POWER SYSTEMS, INC.

PRODUCT INFORMATION BULLETIN

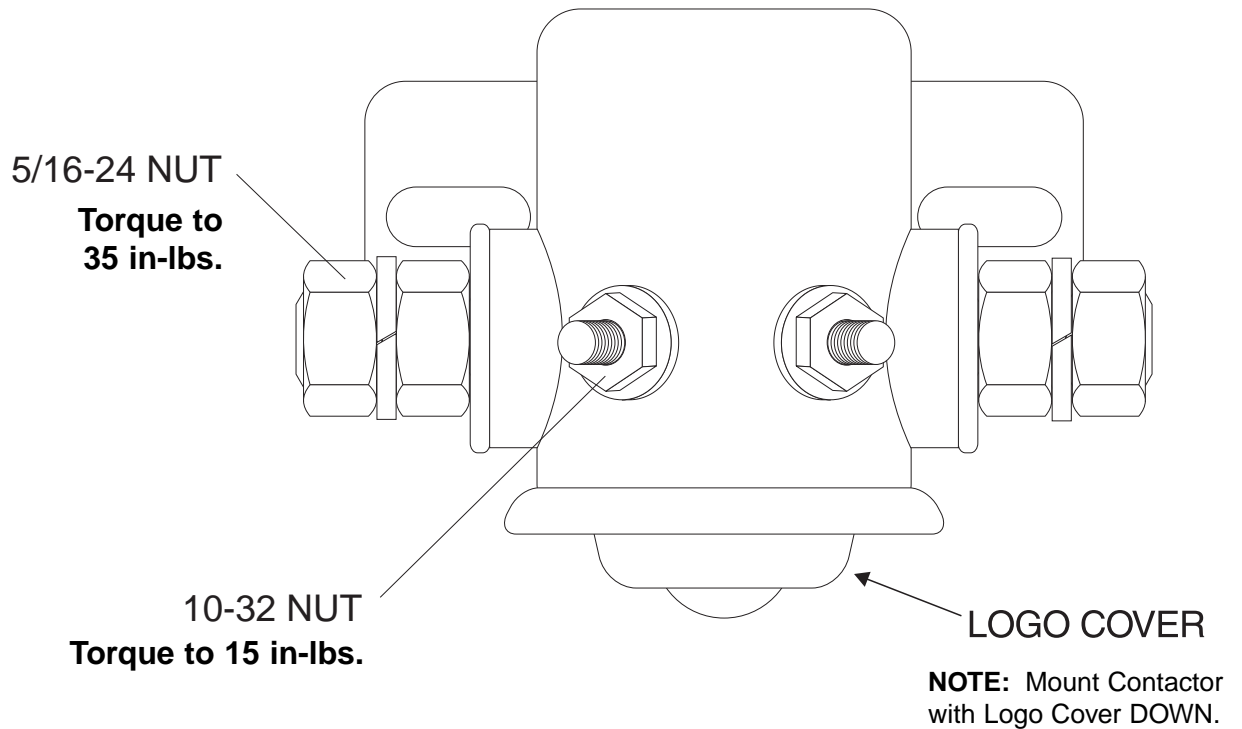
PROBLEM: Over torquing connections

CORRECTIVE ACTION: The terminals must be torque tightened to the following specifications.
 "Large" terminals to 35 in-lbs.
 "Small" terminals to 15 in-lbs.

NOTE: Over torquing can cause the contacts to rotate internally. This can cause component failure.

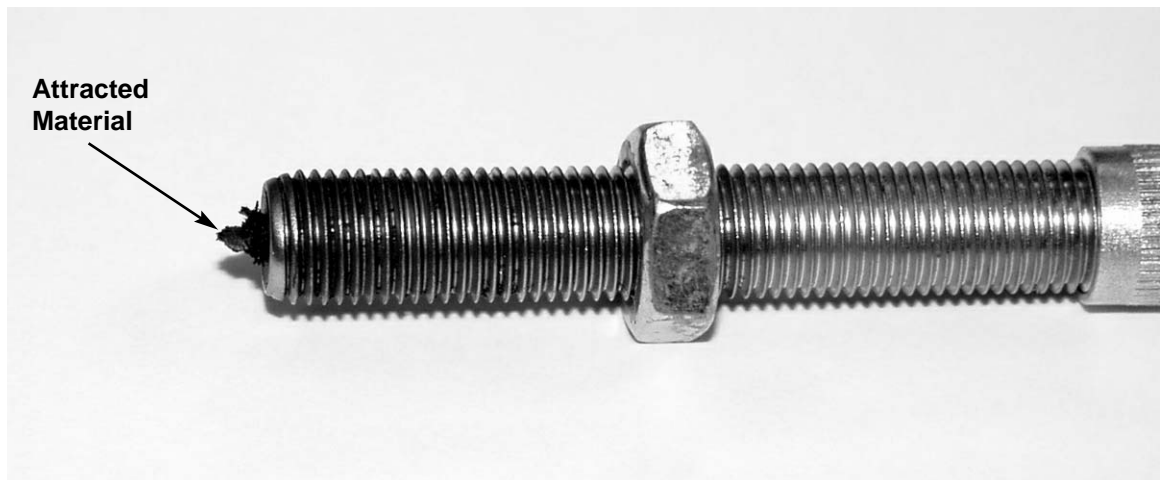
PROBLEM: Distorted signals to the PCB causing speed related shutdowns.

CORRECTIVE ACTION: During the semi-annual Maintenance trip, or every six months, remove any Magnetic Pick Up(s) and clean off anything attracted to the tip of the Pick Up(s).

Once the Sensor(s) has been cleaned off, install the Sensor(s) and set to 1/2 to 3/4 out from the flywheel. Ensure the Sensor(s) are bottoming out on a tooth and not between two teeth. If not on a tooth, use a screwdriver to move the flywheel to get a tooth. **DO NOT USE ENGINE FAN TO MOVE THE FLY-WHEEL.**

Figure 1

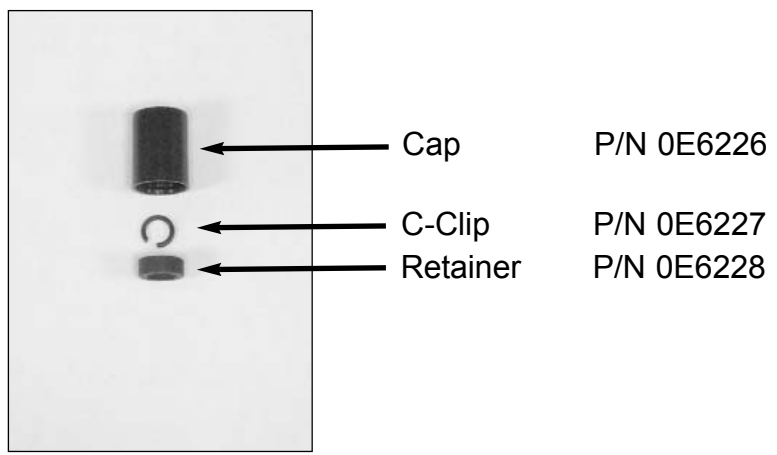
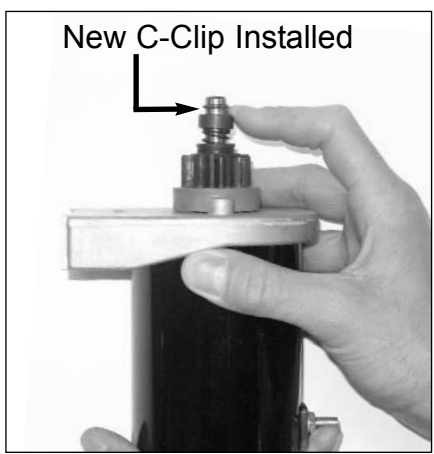
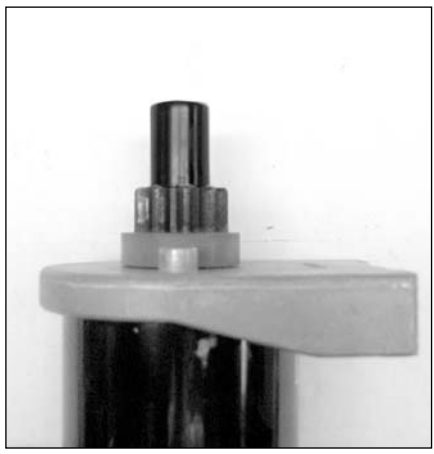
- SYMPTOM: Starter motor C-clip comes off, causing impaired starter bendix operation.
- CORRECTIVE ACTION: Replace C-clip, retainer and cap. Use service Kit Number 0E6225.
(Figure 1).

1. Remove the starter motor from engine.
 2. Remove and discard cap, C-clip and retainer. **Retain the original spring.**
(Figure 2).
 3. Re-install the spring and new retainer. (Figure 3).

4. Using a pair of pliers, spread new C-clip just enough to fit around starter shaft. Using pliers slip C-clip back into position in groove near tip of shaft and flex tight.

5. Use a small gear puller and grab the retainer with the puller jaws. Pull the retainer over the c-clip. It will snap into place. (Figure 4). Install plastic dust cap. (Figure 5).

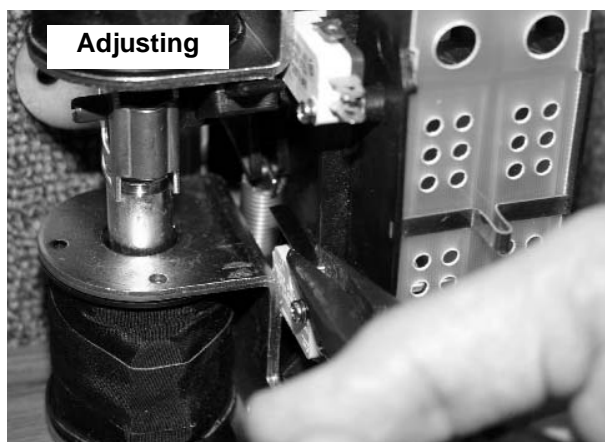
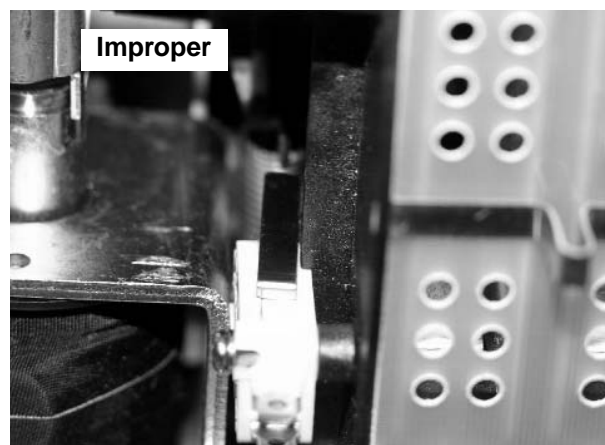
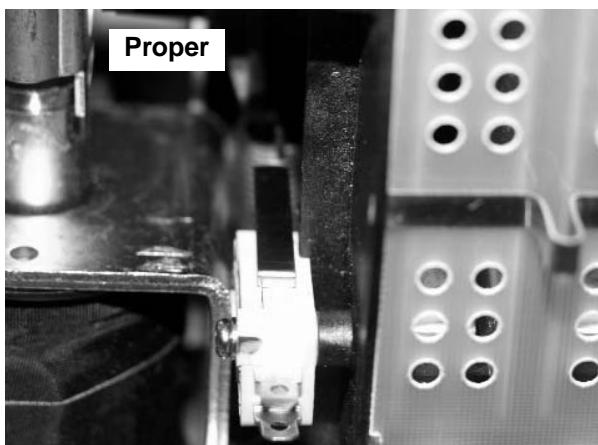
SYMPTOM: Limit switch actuating lever catches on switch housing.

CORRECTIVE ACTION: During the maintenance visit, visually inspect both limit switches using the guidelines below. If an adjustment is required, use a pair of needlenose pliers to GENTLY bend lever away from the housing.

Exploded View - 6.8L Fan Drive, Drawing No. 0D9428-E

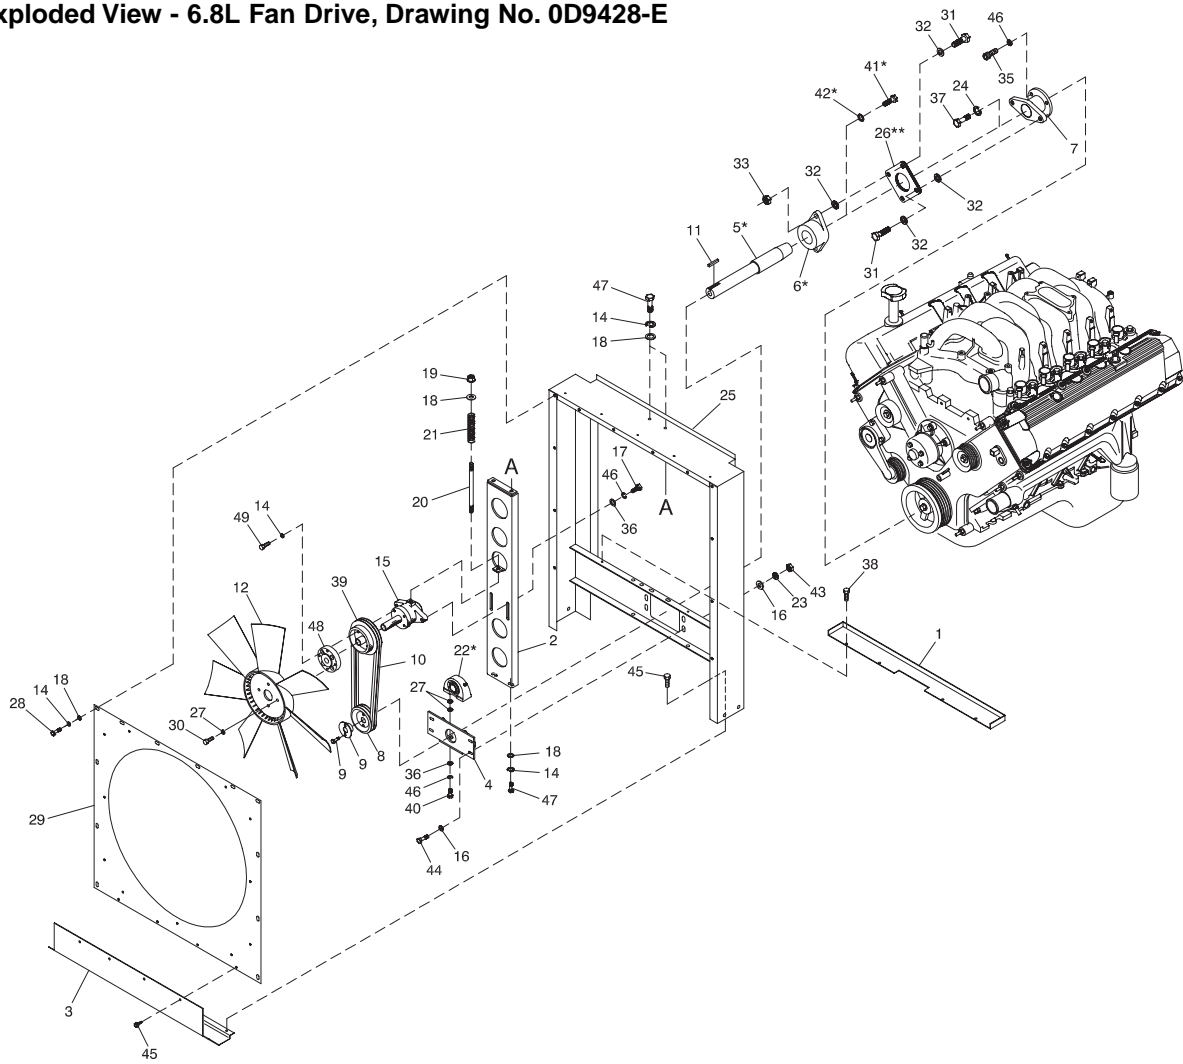
PROBLEM: Possible Fan Drive Failure

CORRECTIVE ACTION: Replacement of Fan Drive Hub with 0E8909. With each ordered, direction will be sent out as to how to remove and replace the 0E8909.

1. Remove the fan.
2. Loosen the lock down bolts, located behind the bearing housing.
3. Loosen the tensioner ring.
4. Remove belts.
5. Remove the Sheave Hub (Item #9).
6. Remove Pulley (Item #8).
7. Remove bearing support bolt (Pillow Block Bearing).
8. Remove two (2) 5/16 inch bolts on flange. **DO NOT REMOVE NUTS, ONLY THE BOLTS!**
9. Remove the jackshaft assembly
10. The Hub (Item #7) can now be accessed and removed.
11. Install new Hub (part no. 0E8909).
12. Repeat process in reverse.

NOTE: Make sure that the larger washer removed from the flange goes on first, convex side going towards the hole. This is used to center the bolt. The smaller washer goes before the flex plate, with the convex side going towards the flex plate also.
